**DUKE POWER COMPANY
NUCLEAR GENERATION DEPARTMENT**

**ODCM
OFFSITE DOSE CALCULATION
MANUAL**

Subject: Offsite Dose Calculation Manual (ODCM)
Generic Section - Revision 43

JUSTIFICATION FOR REVISION 43

FIGURE C1.0-1 REV 42 1/1/00
 CATAWBA NUCLEAR STATION
 LIQUID RADWASTE SYSTEM

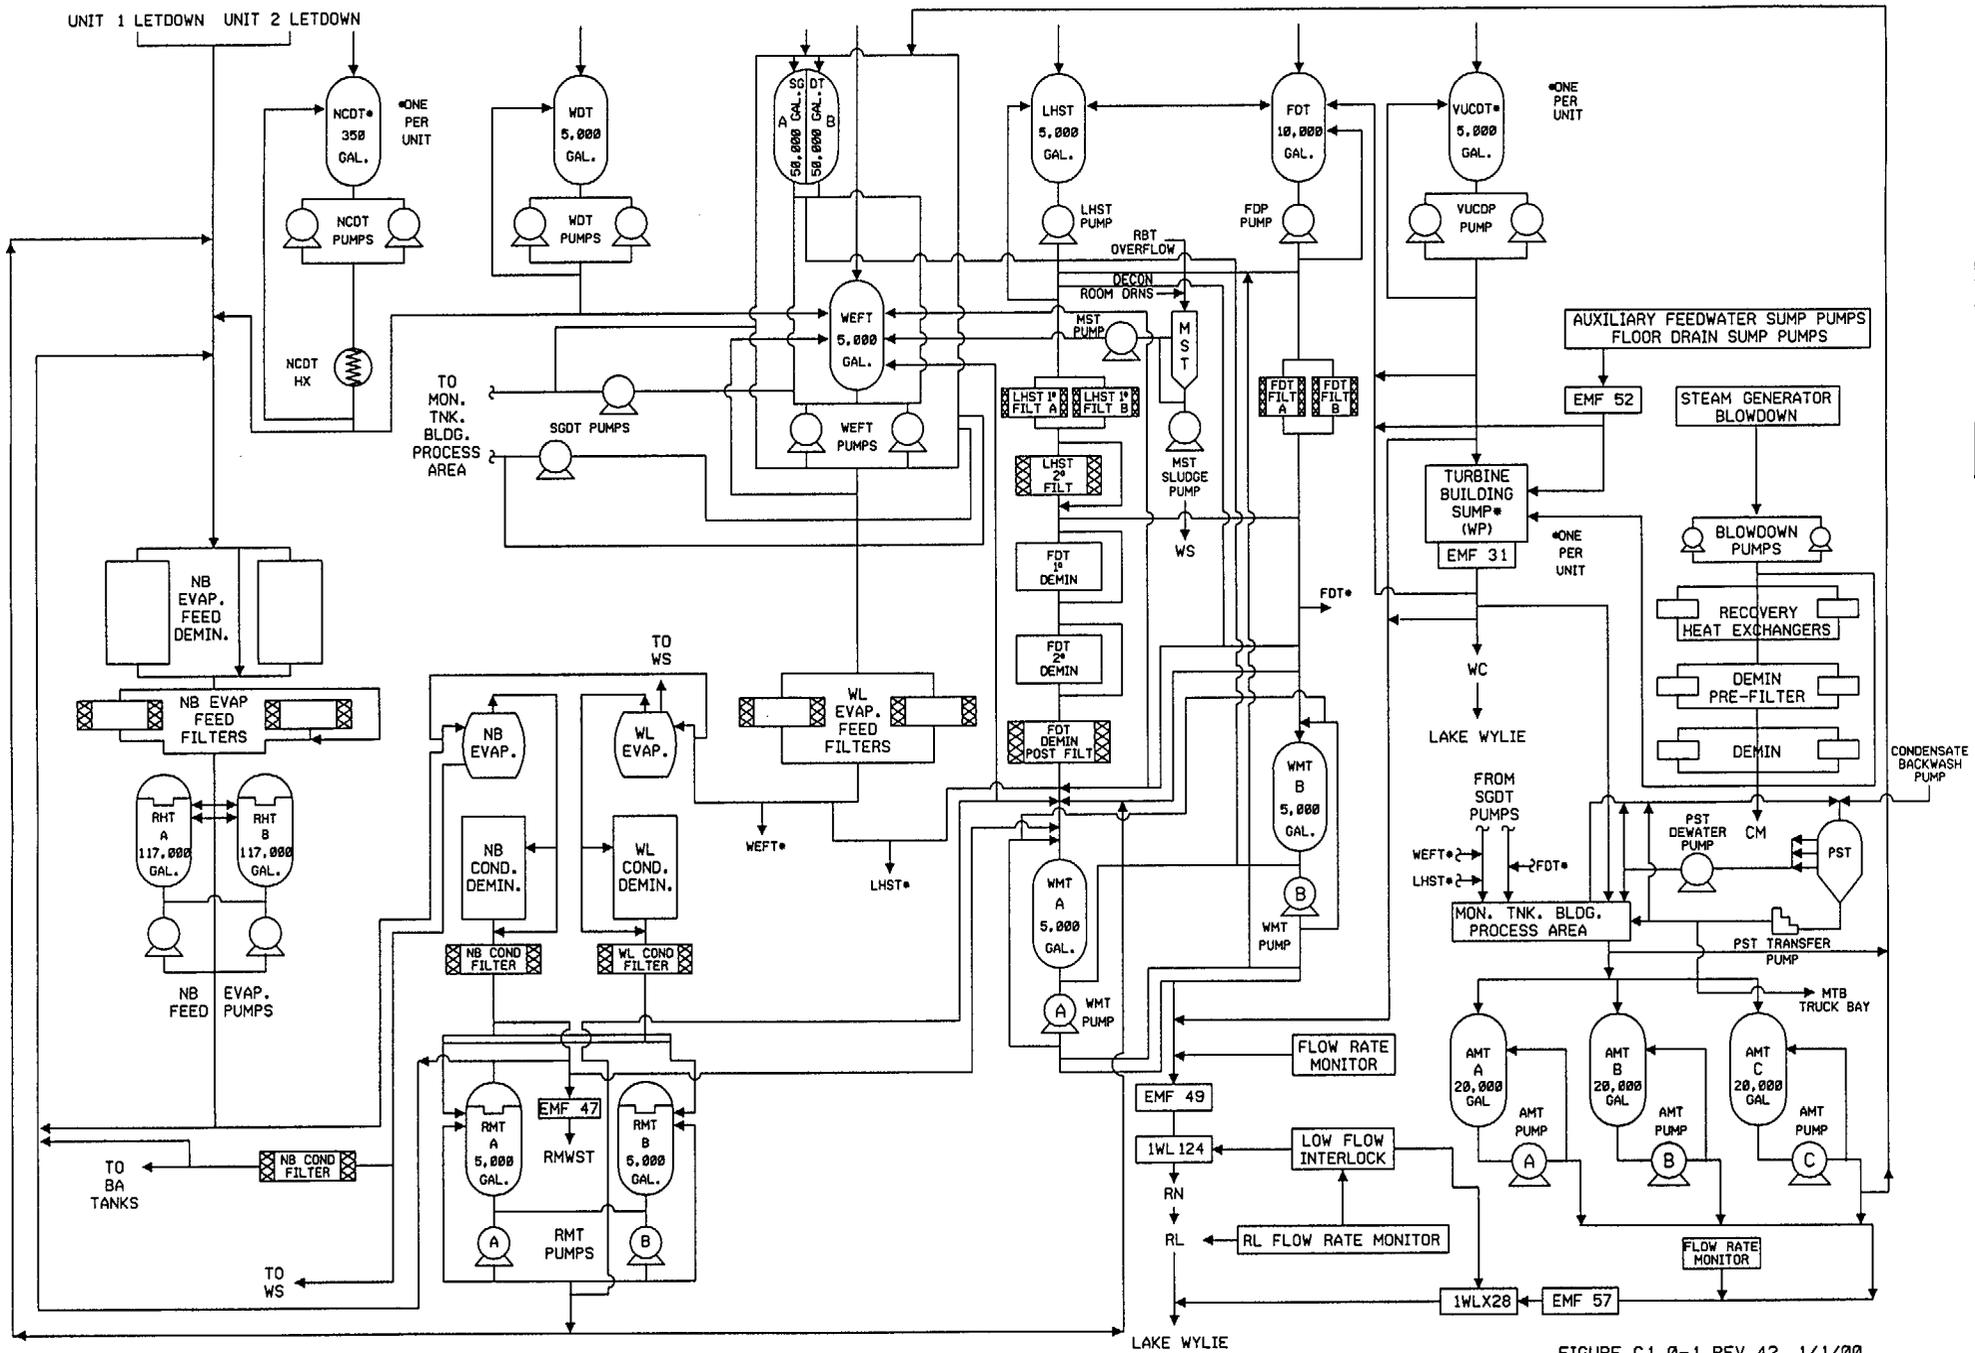
Figure C1.0-1

Removed EMF 44 and EMF 34 from the figure. The monitors are no longer used for any process control functions.

FIGURE C1.0-2
CATAWBA NUCLEAR STATION
GASEOUS RADWASTE SYSTEM
PAGE 1 OF 2

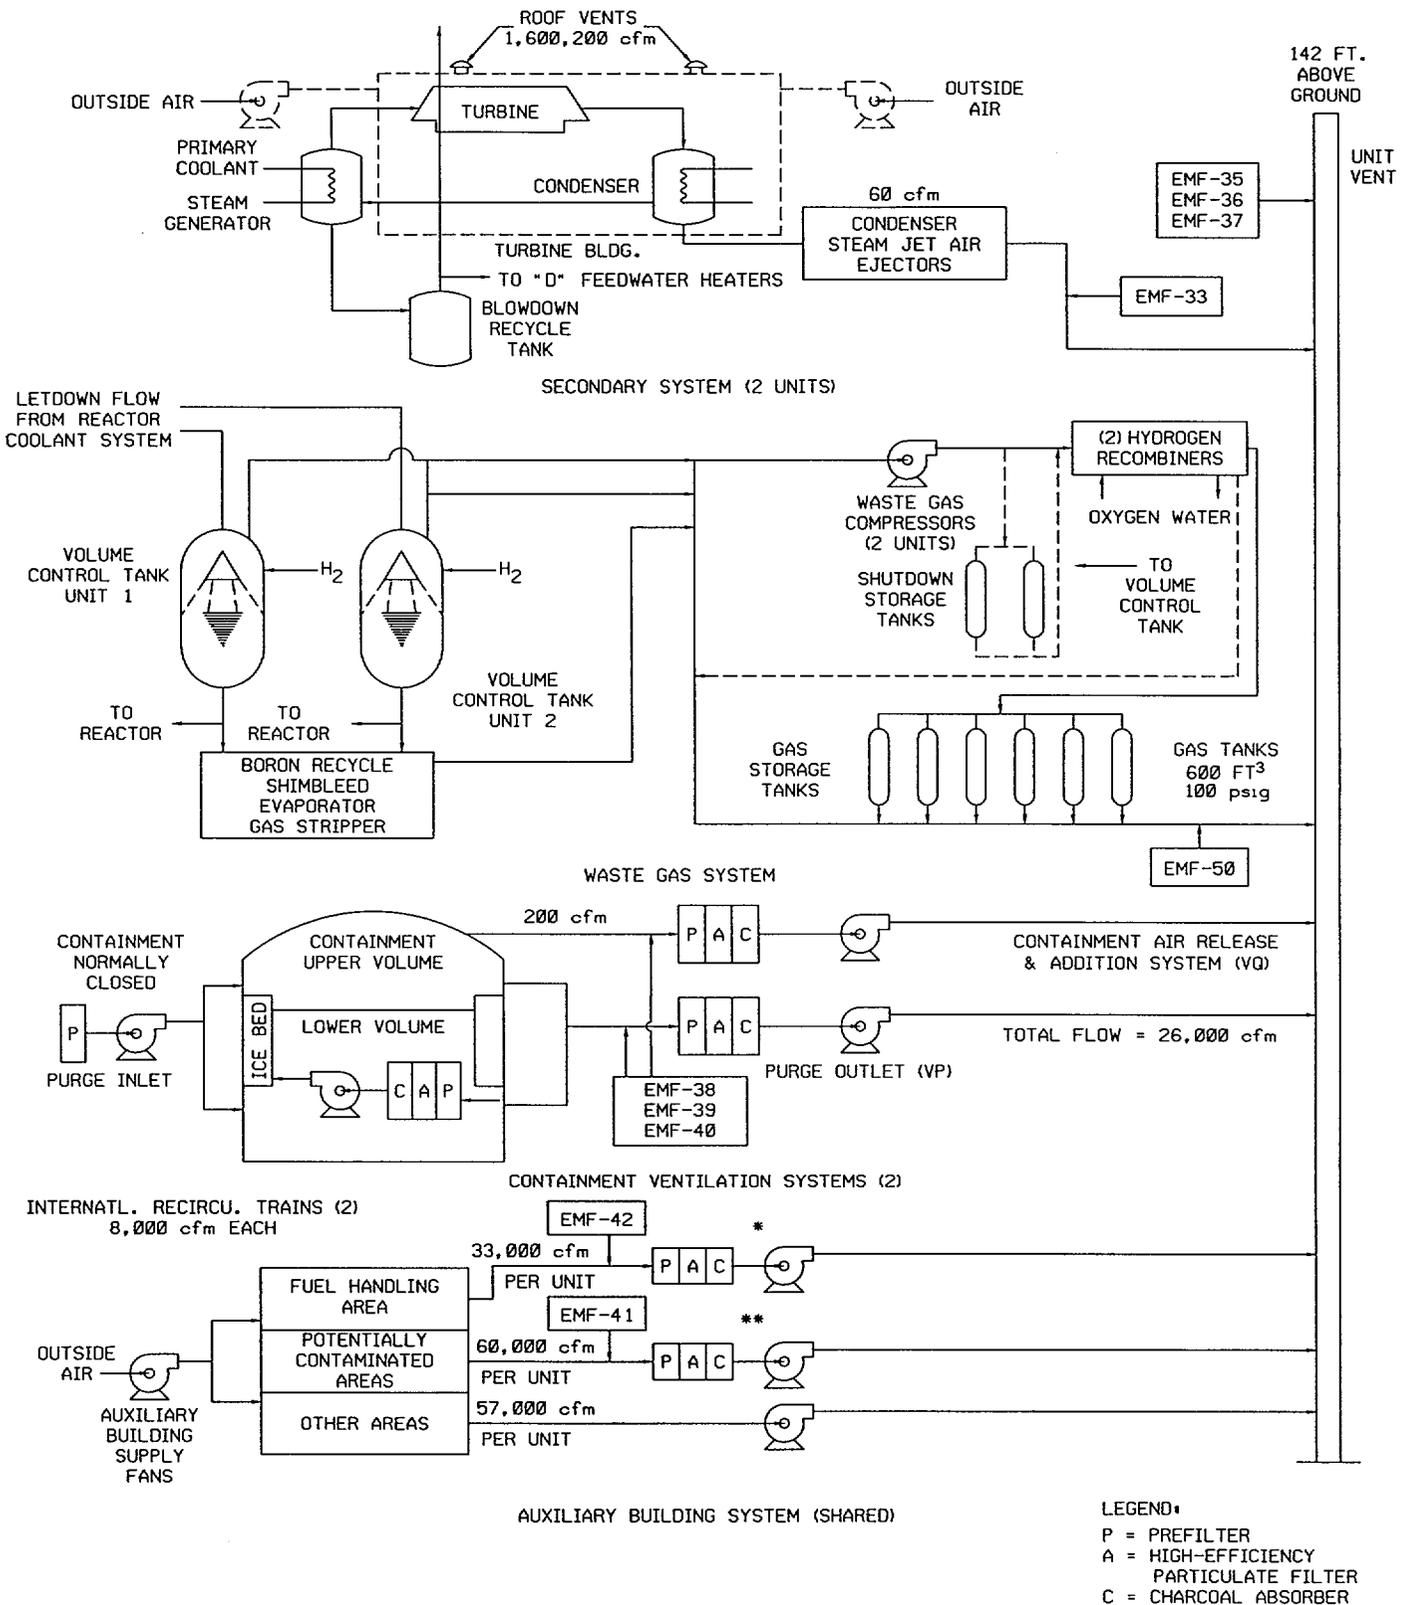
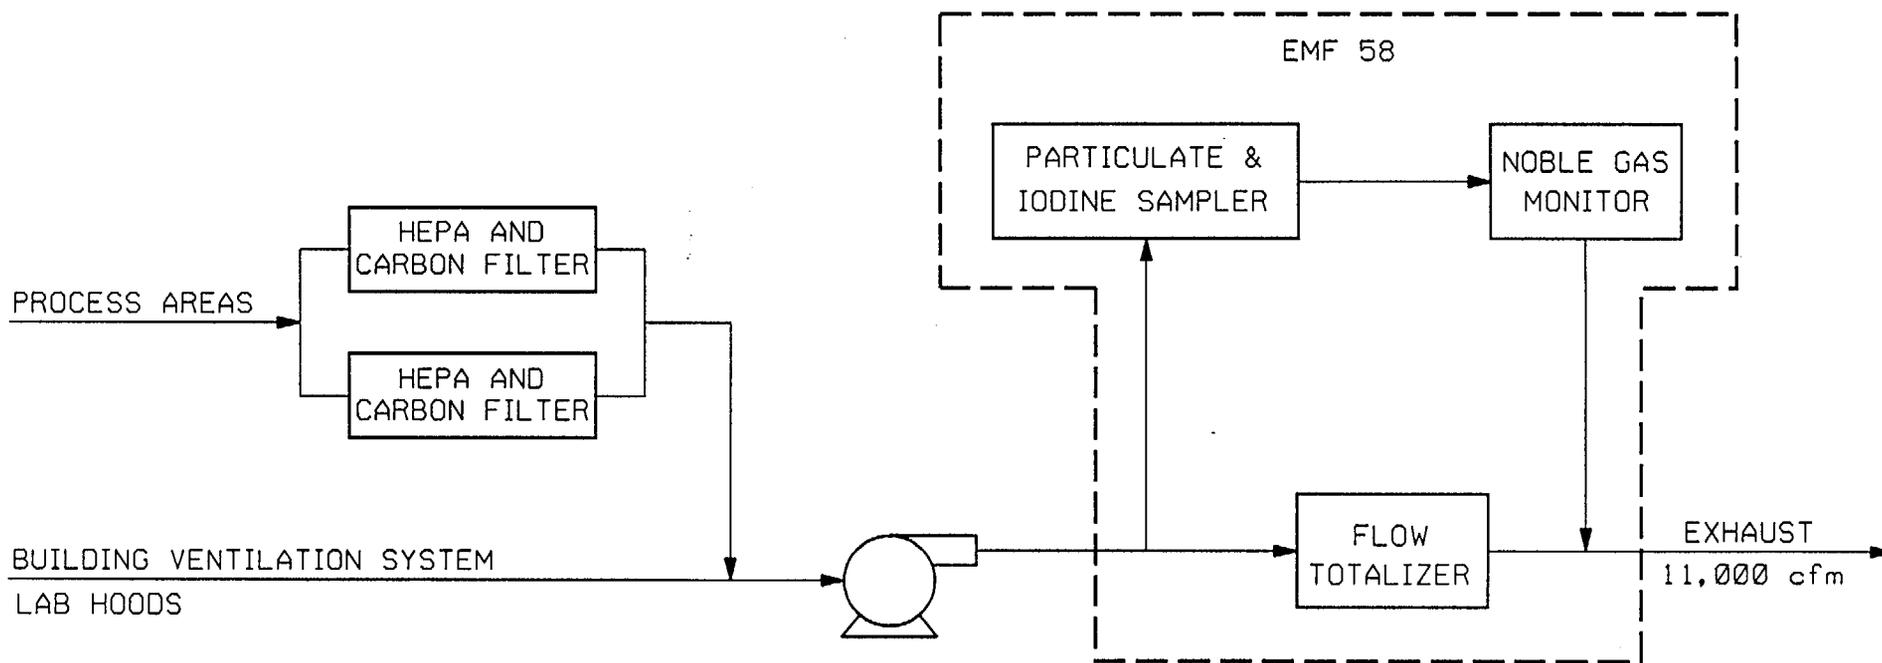
Figure C1.0-2 (two pages)

Removed EMF 34 from the figure.
